**DOLBY LANDFILL PHASE 2 AND PHASE 3 COVER UPGRADE  
MAINE BUREAU OF GENERAL SERVICES**

**ADDENDUM NO. 2  
January 5, 2022**

**CB #23 Exterior**

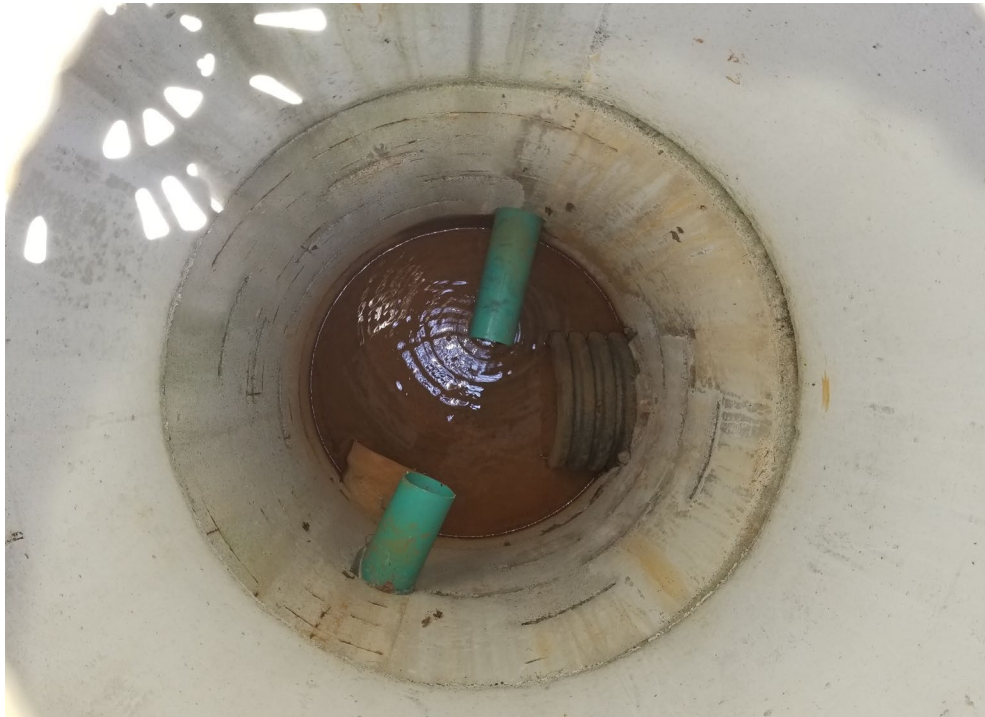
- **A company looking to quote the pipe cleaning wants to visit the site and look in a few structures on Tuesday next week. Is this possible?**

We have included pictures of the catch basins within the project limit as Attachment 1; only main collection pipes at bottom of structure will need to be cleaned.
